**RULE NO.: R161-19.15**

**NOTICE OF PROPOSED RULE**

R161-19.15: Proposed revision to the Standard Details 503 & 520

### **Rule 1 – Standard Details 503 & 520**

STANDARD NO.  
503S-7W

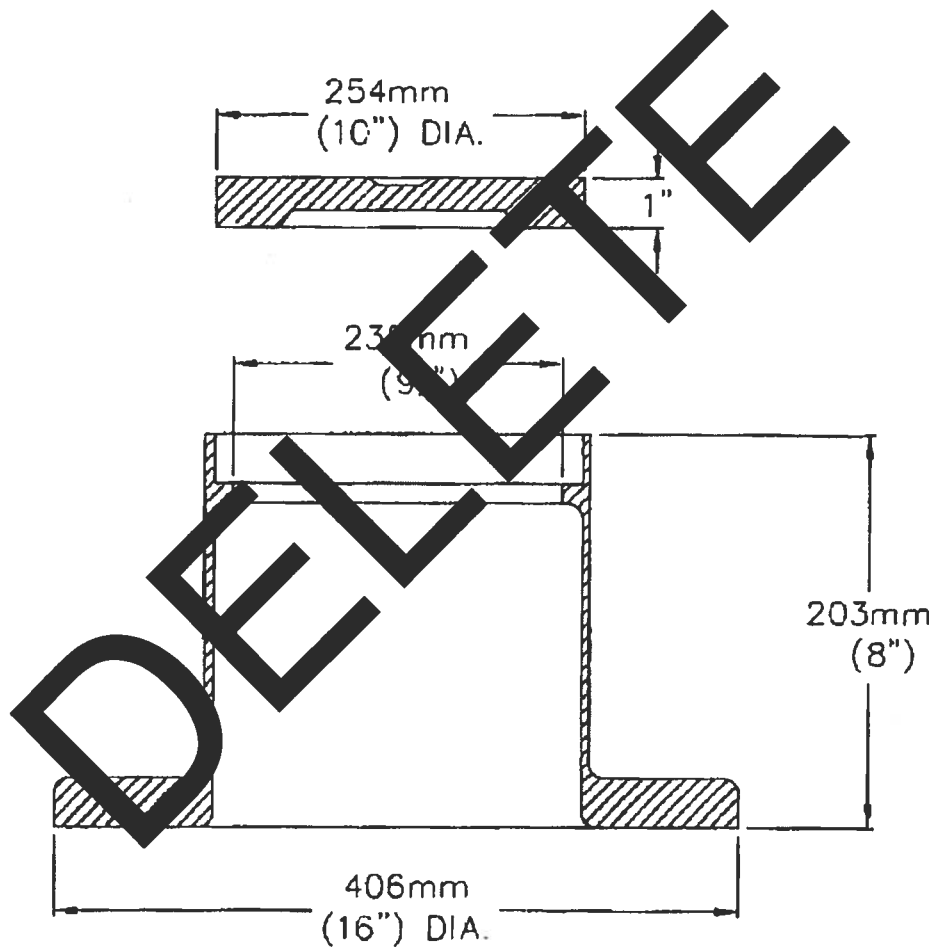
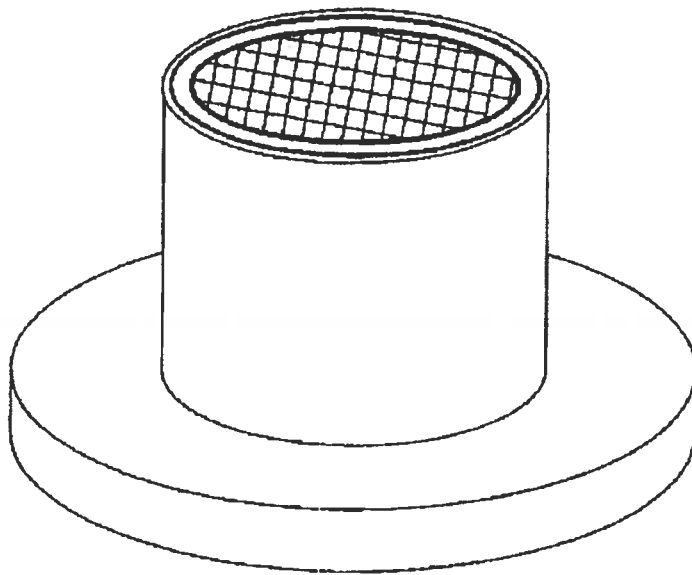
- Standard Detail 503S-7W – This Standard Detail is being deleted to transfer the applicable information to Standard Detail 520-AW-03.
- Standard Detail 520-AW-01B – This Standard Detail is being revised to move “Meter Box and Cover” out of “Materials to be installed by Plumbers”. It will also remove the option to mount ball valves vertically.
- Standard Detail 520-AW-03 – This Standard Detail is being created to remove the "locking lid" option. It will also change the reference from "SPL WW-622" to "SPL WW-145A", remove the concrete pad, include applicable information from Standard Detail 503S-7W, and discontinue Standard Detail 503S-7W.
